Project	IEEE 802.16 Broadband Wireless Access Working Group < http://ieee802.org/16 >
Title	Ranging Procedure: Motorola's contribution comments
Date Submitted	2004-08-25
Source(s)	Evgeny Goncharov, Jae-Hyok Lee, e.gontcharov@samsung.com Seung Joo Maeng, Jaeho Jeon Samsung Electronics Co., Ltd. Yury Karpitsky kry@box.vsi.ru KODOFON
Re:	Ranging Improvement for 802.16e OFDMA PHY
Abstract	Comparison of the current and Motorola's ranging scheme
Purpose	Informative contribution
Notice	This document has been prepared to assist IEEE 802.16. It is offered as a basis for discussion and is not binding on the contributing individual(s) or organization(s). The material in this document is subject to change in form and content after further study. The contributor(s) reserve(s) the right to add, amend or withdraw material contained herein.
Release	The contributor grants a free, irrevocable license to the IEEE to incorporate material contained in this contribution, and any modifications thereof, in the creation of an IEEE Standards publication; to copyright in the IEEE's name any IEEE Standards publication even though it may include portions of this contribution; and at the IEEE's sole discretion

Figure 1 M-sequence cross correlation properties, scattered subcarriers, 2048-fft size, code length 144

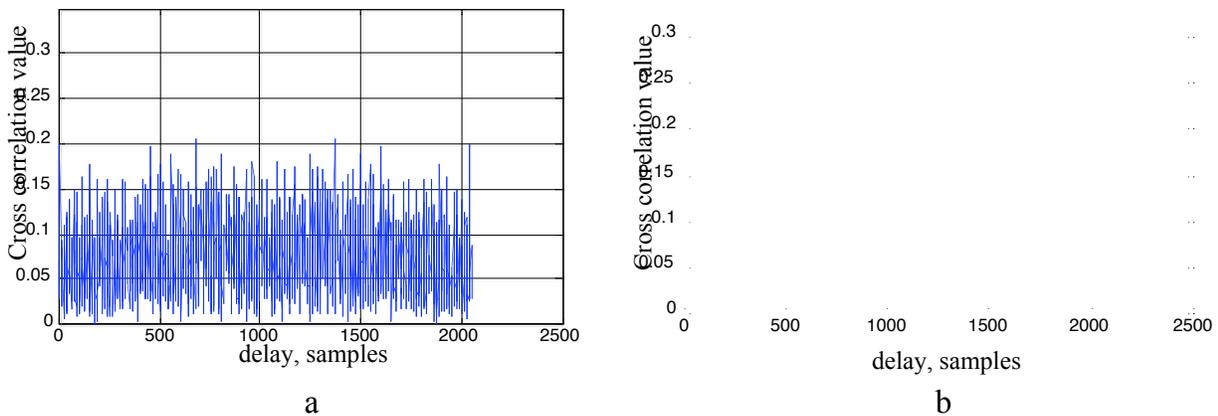
The following conclusion of document [2] is under discussion here:

a. The placement of ranging subcarriers across the whole band degrades the performance in both code detection and timing offset estimation.

The cross correlation properties of both investigating approaches were calculated to consider the first sentence. Results of simulations are presented in the Figure 1. Parameters used in this document are the same as presented in bottom part of Figure 4 of [2].

Comparative analysis of two functions from Figure 1 shows, that statistical properties of both of them have much in common. The total power of interference produced by GCL sequence is equal to $\sqrt{\dots}$, and the same parameter for M-sequence is equal to $\sqrt{\dots}$.

Considerable difference is present in standard deviation of cross correlation values only: GCL sequence has \dots , and the corresponding parameter for M-sequence is equal to \dots .

Figure 2. Successive detection (SD – solid lines) and false alarm (FA – dashed lines) rates in Vehicular B (a) and Pedestrian B (b) environment, 5 users. 1024-fft size, code length 144

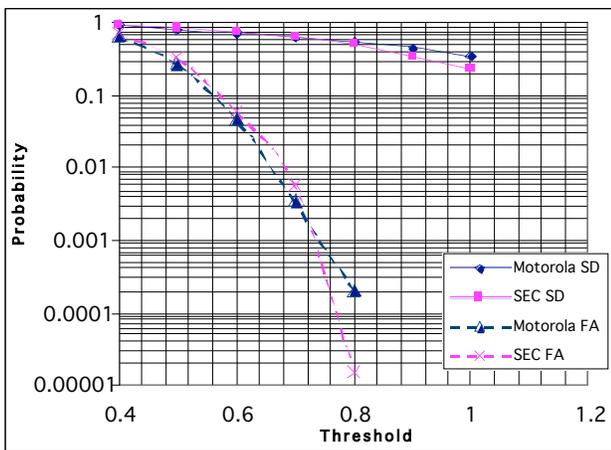
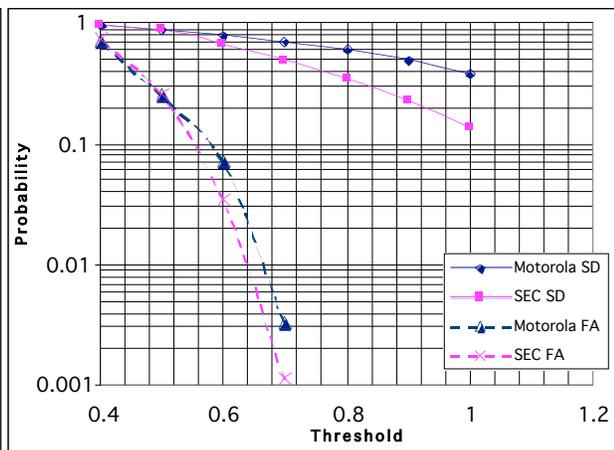
The results of simulations of code detection of GCL- and M- sequences in Jakes fading multipath environment [3] are presented in Figure 1, and in Table 2 - Table 5. Threshold value is encountered in parts of desired user signal energy. Recommended threshold value is distinguished by color.

As it could be seen from the simulation results, for correctly selected threshold values the difference in code detection and false alarm probability between two schemes is not considerable.

Figure 3. Scattered subcarriers M-sequence auto correlation properties (a) 2048-fft size, code length 144, contiguous subcarriers GCL sequence auto correlation properties (b) 2048-fft size, code length 144.

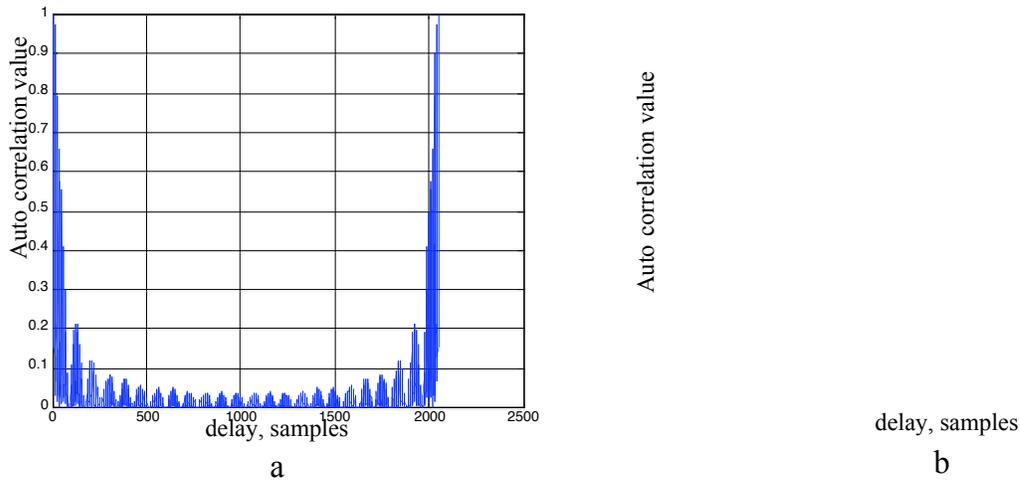
Typical auto correlation properties of GCL and M – sequences are presented in the Figure 3 (no propagation channel), Figure 4 -Figure 5 (Vehicular B propagation channel model).

For the no propagation channel case statistical properties of auto correlation functions of both signals do not depend on the code number (“u” value in case of GCL, and seed number in case of M) (Table 6).

As it could be seen from the Table 6, no considerable auto correlation power losses of M-sequence comparing to GCL is obtained, as well as no considerable STD losses are observed.
